## Public Input No. 175-NFPA 70-2019 [ Global Input ]

## Public Input No. 2691-NFPA 70-2020 [ Definition: Attachment Fitting. ]

**Figure 406.3(E) Controlled Receptacle Marking Symbol.**

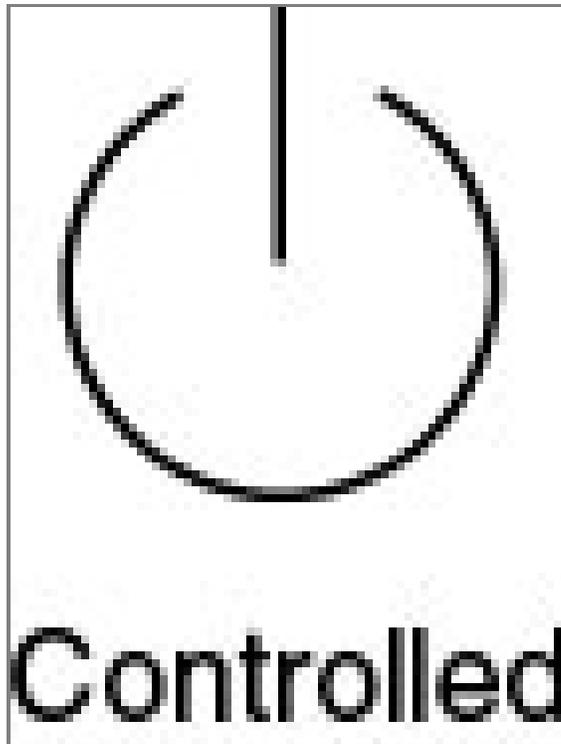
All nonlocking-type, 125-volt, 15- and 20-ampere receptacles that are controlled by an automatic control device, or that incorporate control features that remove power from the receptacle for the purpose of energy management or building automation, shall be permanently marked with the symbol shown in Figure 406.3(E) and the word “controlled.”

For receptacles controlled by an automatic control device, the marking shall be located on the receptacle face and visible after installation.

In both cases where a multiple receptacle device is used, the required marking of the word “controlled” and symbol shall denote which contact device(s) are controlled.

Figure 1 – Typical Test Circuit Diagram

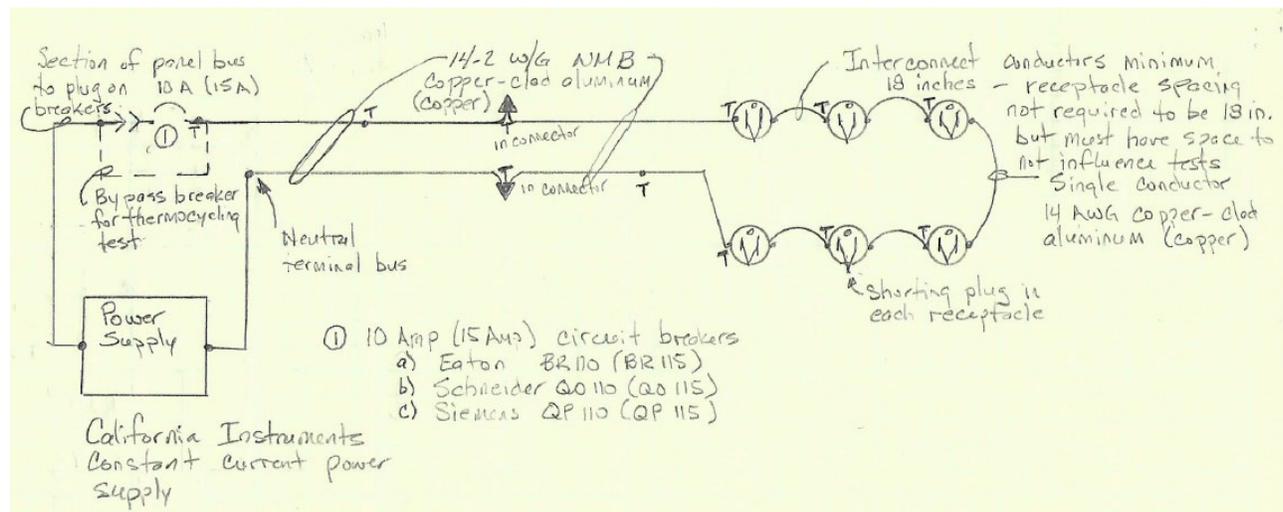
The test circuit diagram shown in figure 1 above provides the basic layout of one (1) testing circuit consisting of one (1) circuit breaker, the conductor (14 AWG copper-clad aluminum or copper NM-B cable) two wire-splicing devices, and six (6) single receptacles. To complete tests 1 through 4 as described below, three (3) of these test circuits were assembled at a time. Photos 1 through 3 in Appendix A show the general test setup for completing the static heating testing. Each of the three (3) circuits have one of the manufacturer's (mfg. 1, mfg. 2, and mfg. 3) circuit breaker, the wire splicing devices on the black and white wire as described below, and three (3) each of receptacles from two of the manufacturers. Photos 4 through 7 show each of the setups with a sign indicating the circuit breaker, conductor material, wire splicing devices, and receptacles in that circuit.

**Figure 410.2 Clothes Closet Storage Space.**

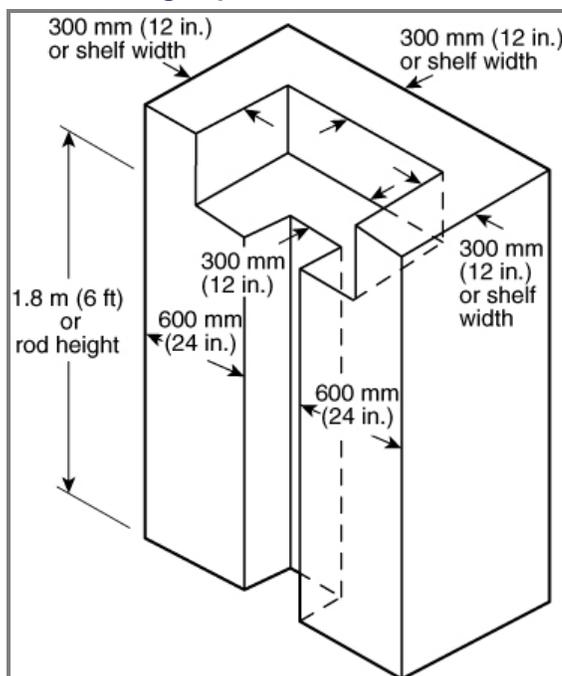
The volume bounded by the sides and back closet walls and planes extending from the closet floor vertically to a height of 1.8 m (6 ft) or to the highest clothes-hanging rod and parallel to the walls at a horizontal distance of 600 mm (24 in.) from the sides and back of the closet walls, respectively, and continuing vertically to the closet ceiling parallel to the walls at a horizontal distance of 300 mm (12 in.) or the width of the shelf, whichever is greater; for a closet that permits access to both sides of a hanging rod, this space includes the volume below the highest rod extending 300 mm (12 in.) on either side of the rod on a plane horizontal to the floor extending the entire length of the rod. See Figure 410.2.

**Figure 410.2 Clothes Closet Storage Space.**

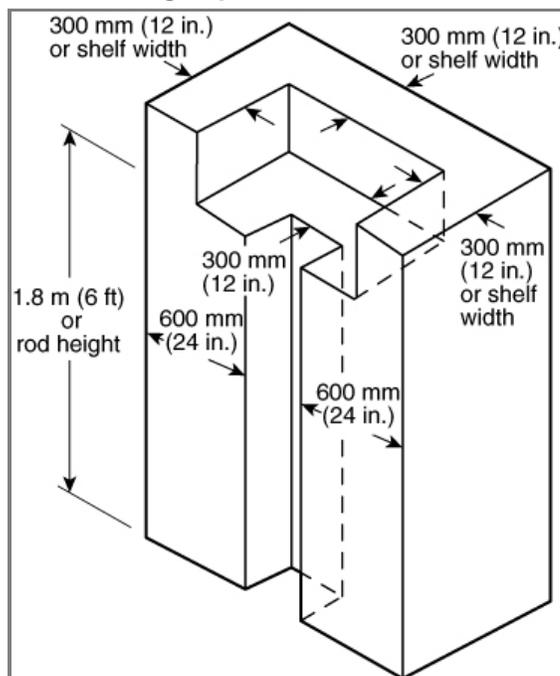
Unless there are doors enclosing each storage or hanging space, The volume bounded by the sides and back closet walls and planes extending from the closet floor vertically to a height of 1.8 m (6 ft) or to the highest clothes-hanging rod and parallel to the walls at a horizontal distance of 600 mm (24 in.) from the sides and back of the closet walls, respectively, and continuing vertically to the closet ceiling parallel to the walls at a horizontal distance of 300 mm (12 in.) or the width of the shelf, whichever is greater; for a closet that permits access to both sides of a hanging rod, this space includes the volume below the highest rod extending 300 mm (12 in.) on either side of the rod on a plane horizontal to the floor extending the entire length of the rod. See Figure 410.2.
